Technical Memorandum

Re: SP 7001-128 TH 13 Project Review (LMRWD No. 2021-025)

Figure 1: Trunk Highway 13 Project Location

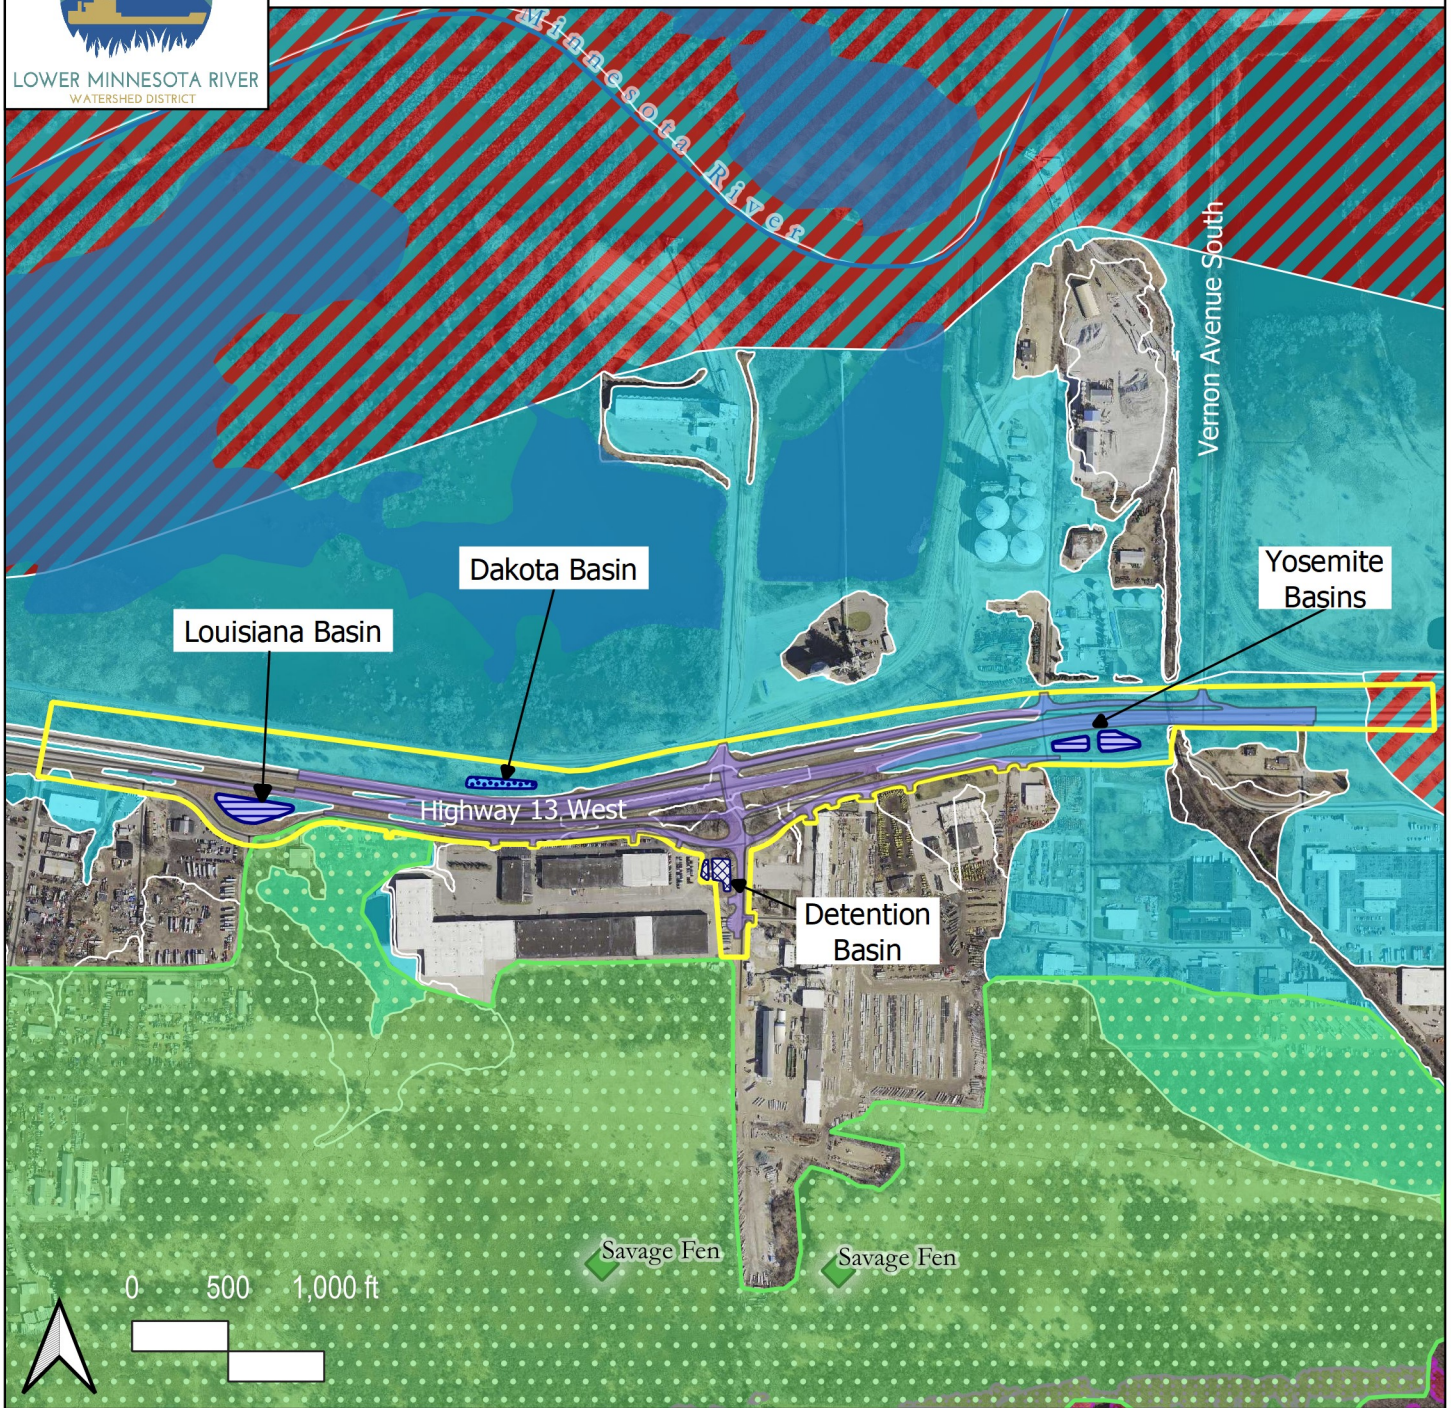
The LMRWD regulates land-disturbing activities that affect one acre or more under Rule B. The proposed Project would disturb approximately 46 acres within the LMRWD boundary. The provided Drainage Overview Map shows a portion of the Project adjacent and potentially encroaching upon the HVRA; please provide the area proposed to be disturbed and volume proposed to be excavated within the HVRA boundary.

The Project proposes 4.2 acres of new impervious surface. The Project appears to be within the HVRA boundary near TH 13 Frontage Road east of the Louisiana Basin, as shown in Figure 1. Please provide the amount of new and reconstructed impervious surface as well as the amount of disturbance within the HVRA as development within the HVRA is subject to higher stormwater standards.

- 1) The area of impact within the HVRA should be reported, as discussed above. The HVRA GIS data are available to download from the LMRWD website here:
